# SAN FRANCISCO PLANNING DEPARTMENT

## Memo to the Planning Commission

*Date:* December 3, 2015  
*Case No.:* **2014.1079D, DRP, -02, -03/ 2014.1080D**  
*Project Address:* **1783 Noe Street**  
*Zoning:* RH-1 (Residential House, One-Family)  
40-X Height and Bulk District  
*Block/Lot:* 6652/016A  
*Project Sponsor:* Geoff Gibson, WinderGibson Architects  
351 9<sup>th</sup> Street, Ste. 301  
San Francisco, CA 94103  
*Staff Contact:* Tina Chang – (415) 575-9197  
[tina.chang@sfgov.org](mailto:tina.chang@sfgov.org)  
*Recommendation:* **Do Not Take DR and Approve Project with Modifications as Proposed**

PROJECT : 1783 Noe Street

PROPOSED THIRD FLOOR PLAN  
WITH SUGGESTED MODIFICATIONS

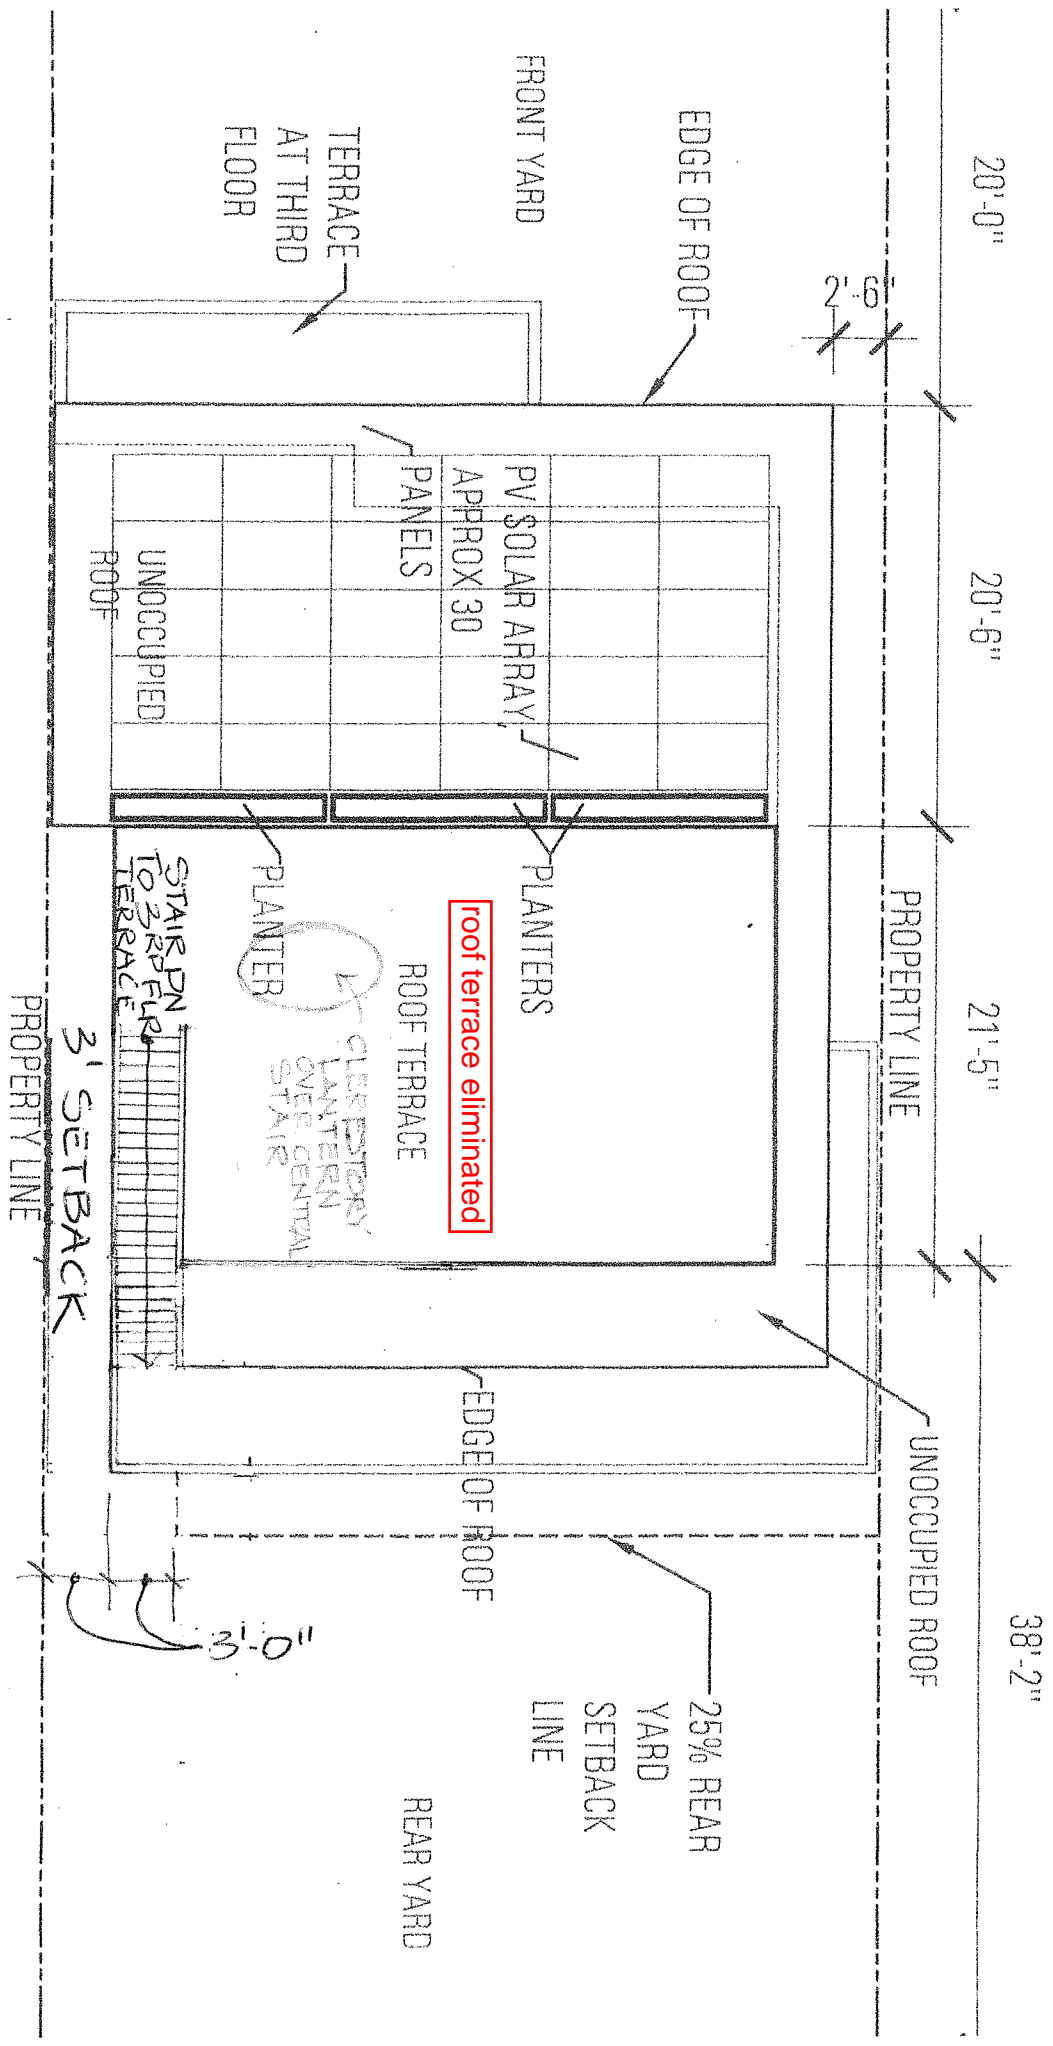
roof terrace eliminated

PROPOSED ROOF DECK PLAN 1783 NDE ST  
WITH SUGGESTED MODIFICATIONS

**EXISTING COTTAGE VS. PROPOSED HOUSE  
PHOTO FROM LAIDLEY STREET**

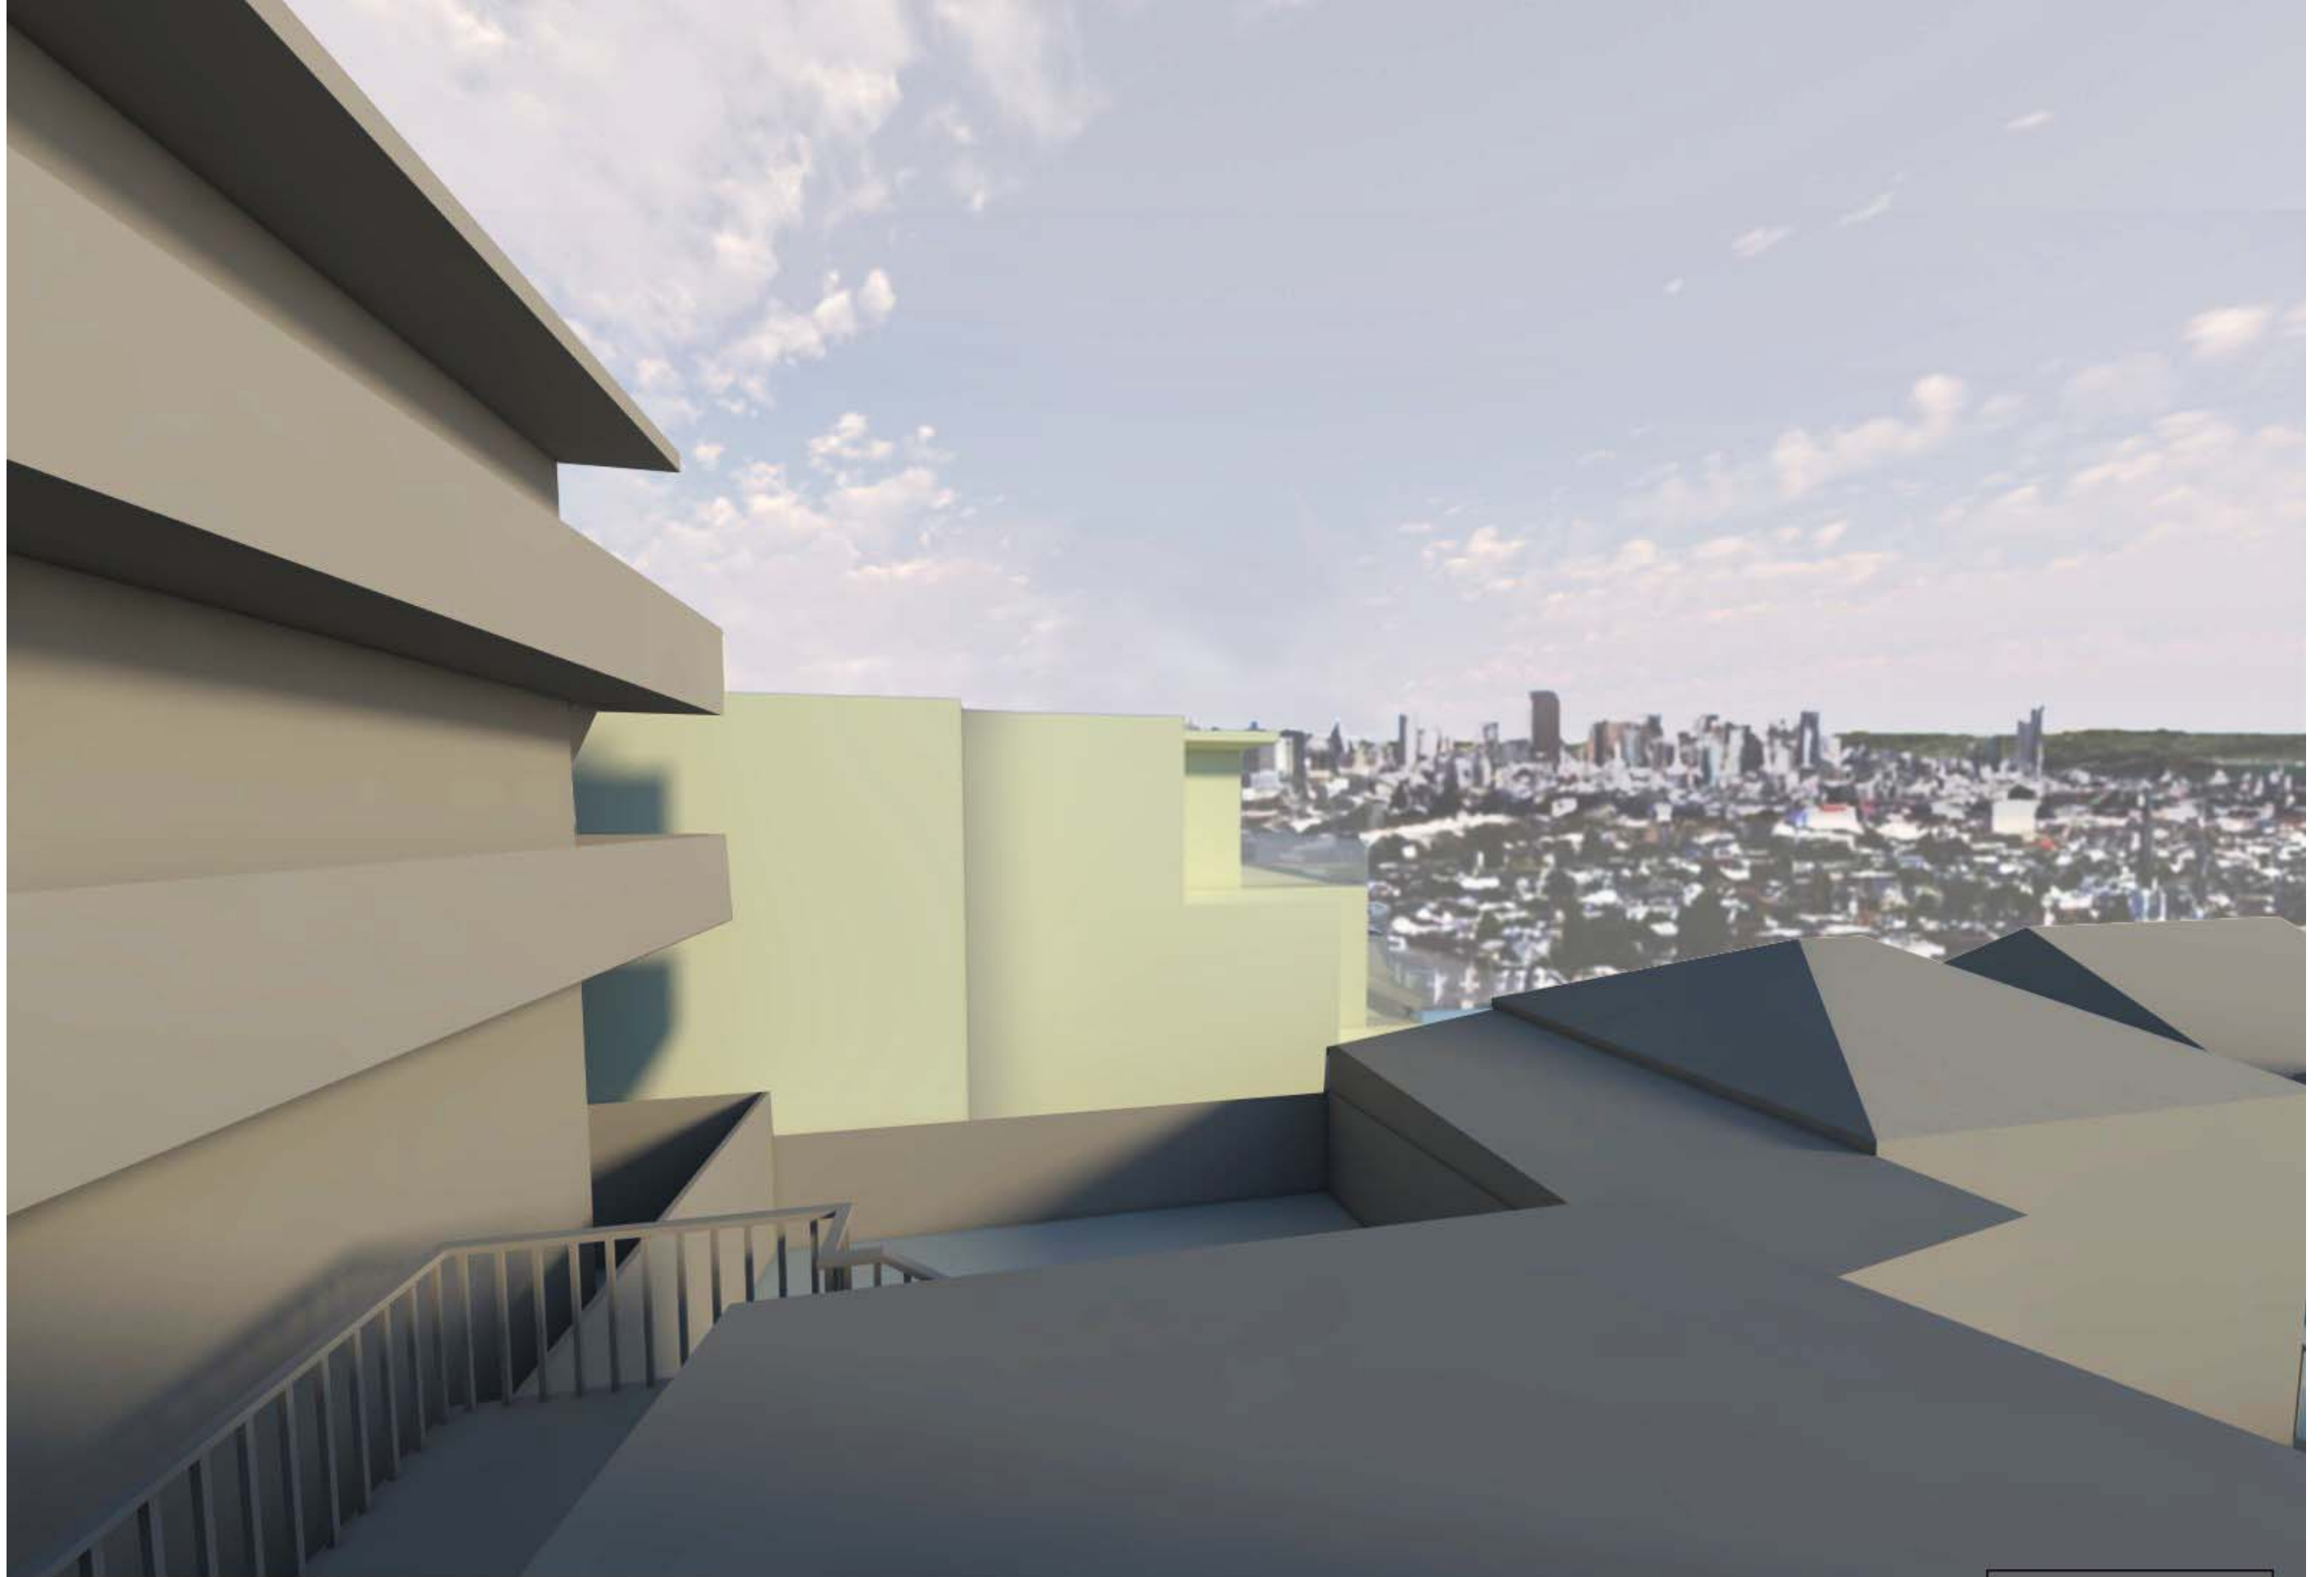
**View from Laidley:** In the original DR filing, the DR Filer provided a photo with a hand-drawn dashed black outline of their supposition of the outline of our proposed project. This outline was dramatically exaggerated. We inserted our original 311 design into this photo. We then inserted a simple massing model of the revised design before you to show the contrast. As you can see, the new massing tucks into the context easily, keeping in scale with the adjacent buildings. This view is essentially the view from DR Filer Tansev's home and we have worked to reduce the impact of the project on his view.

**1783 NOE\_ REVISED BUILDING ENVELOPE 7' SETBACK**  
11.18.2015

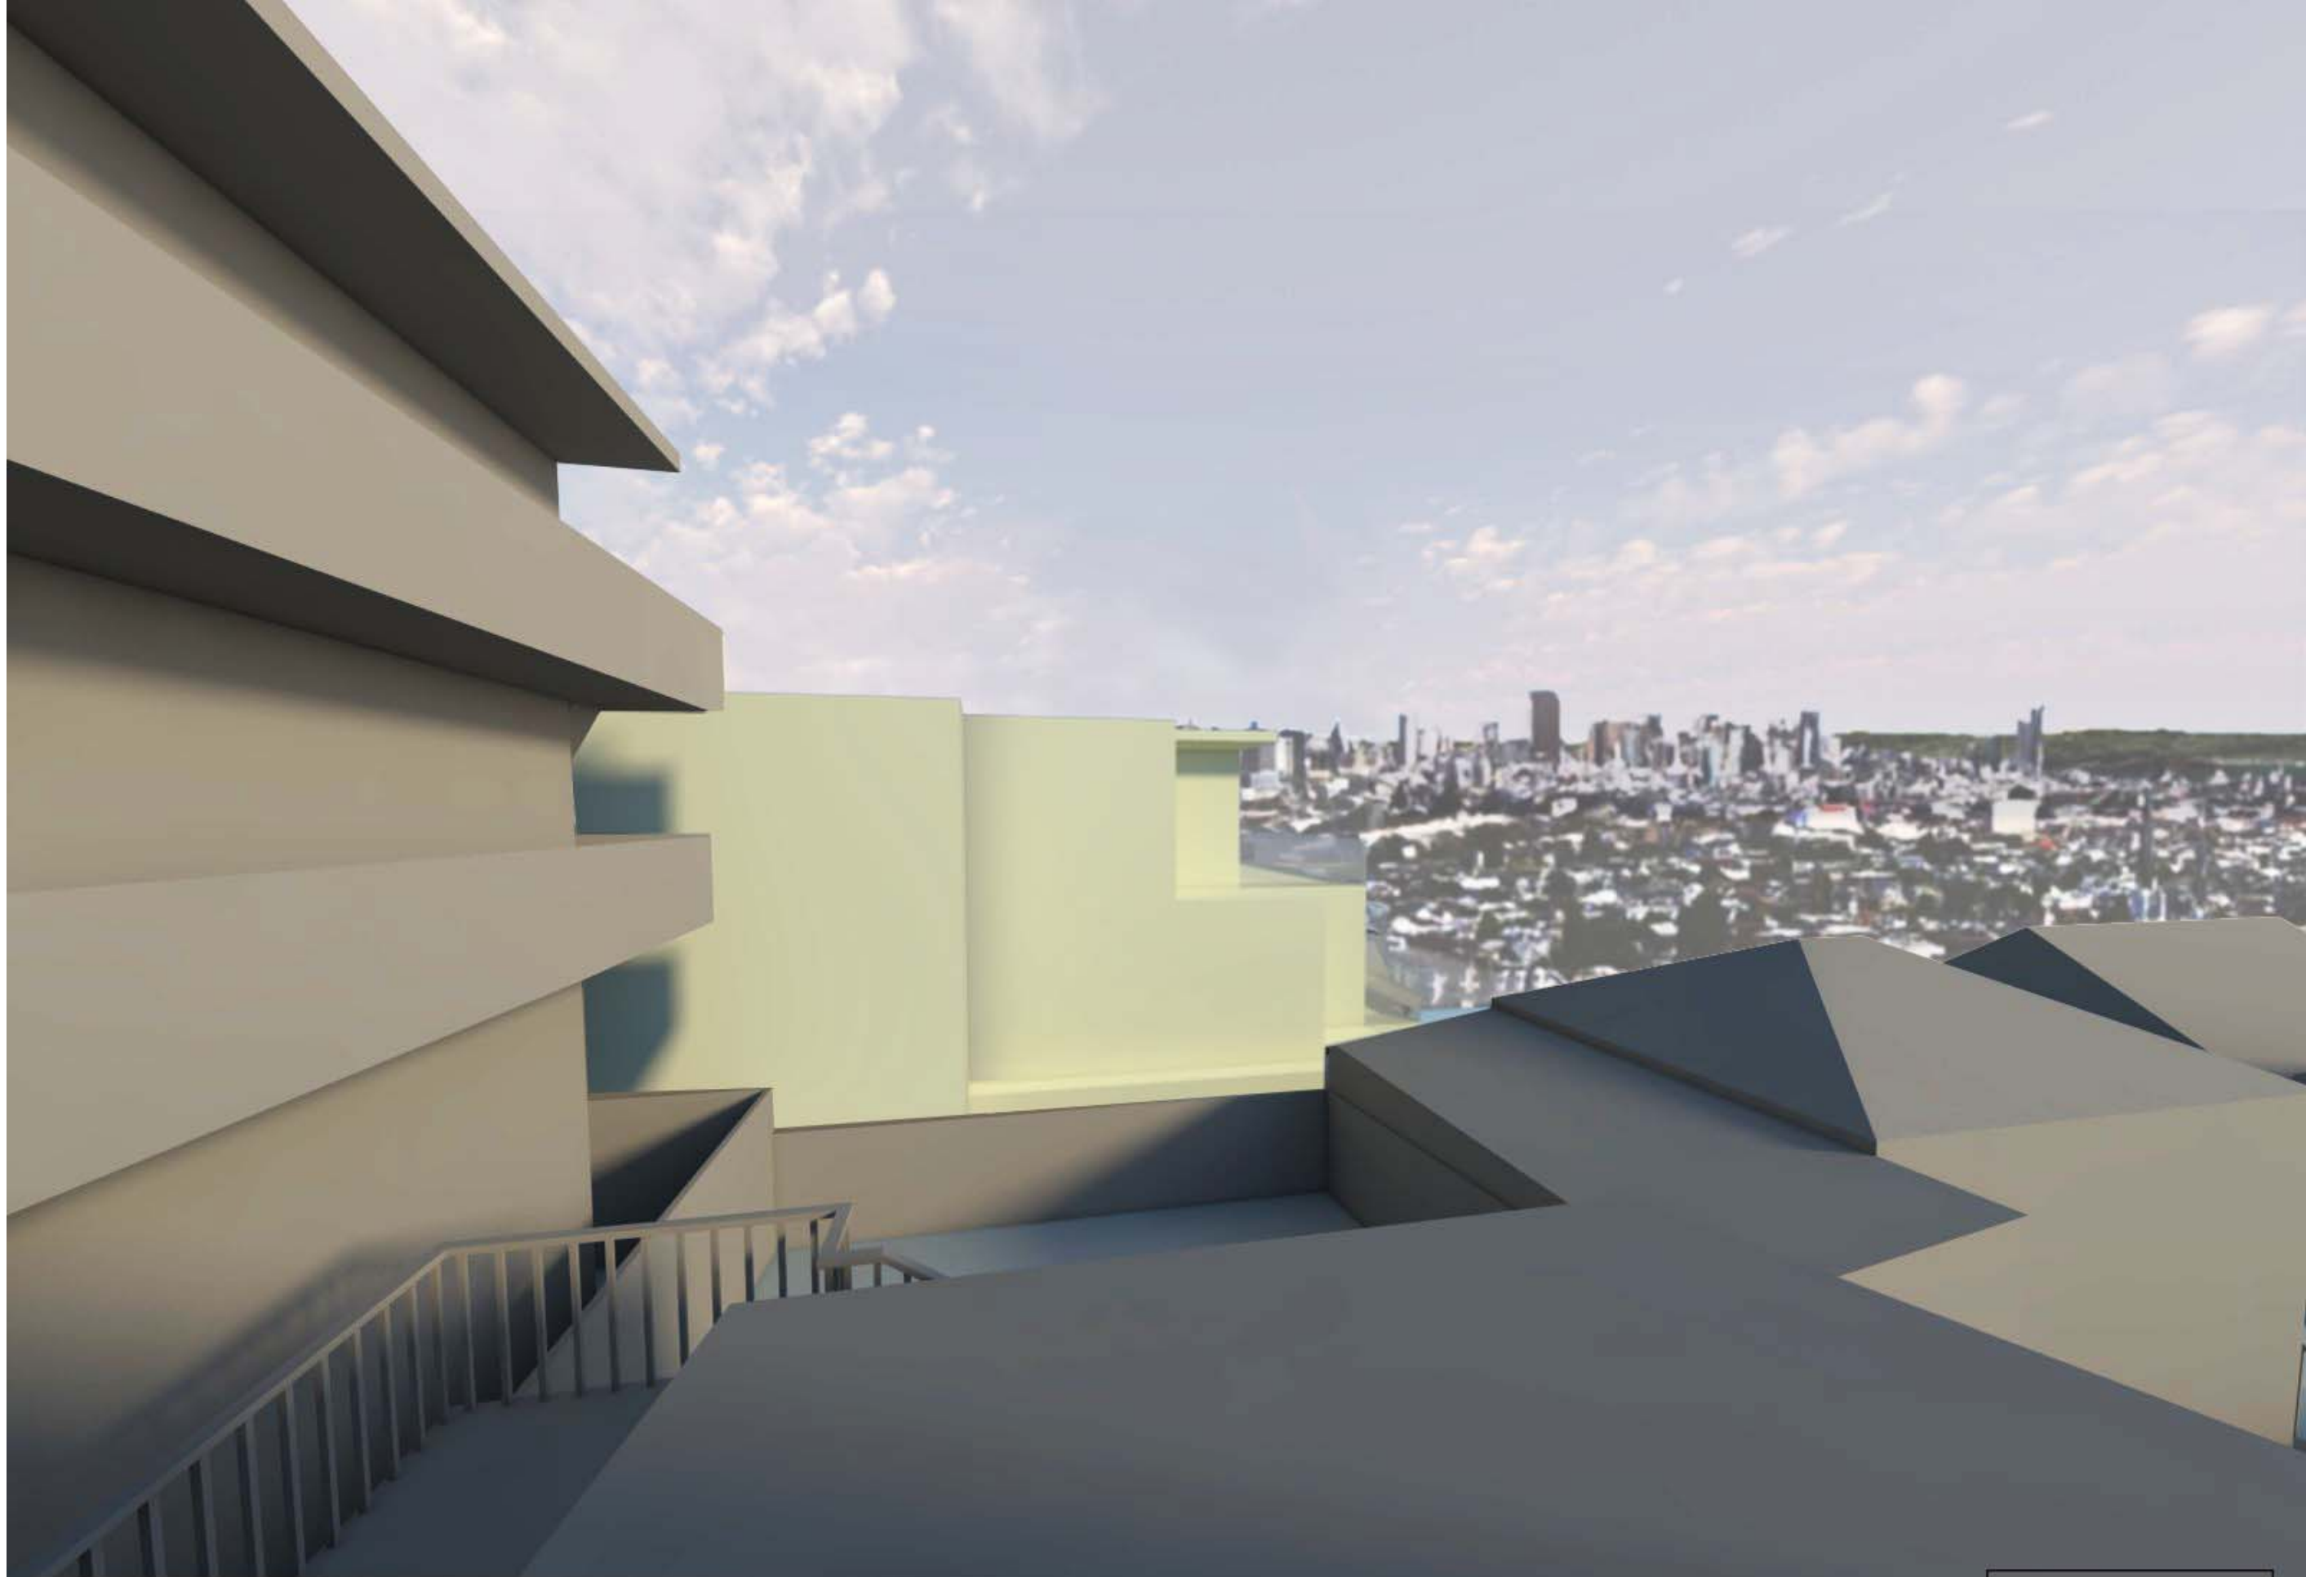
Of all these dimensions, the only one the neighbors have not yet agreed to is the 7' side setback on the south side at the second and third floors. We would like 5'-0" at these floors (since this exceeds the 3' requested by the RDT and Rizzoli's DR filing). The neighbors would like 10'-0". We are willing to compromise at 7'-0". The revised plans you are receiving show this 7'-0" side setback.
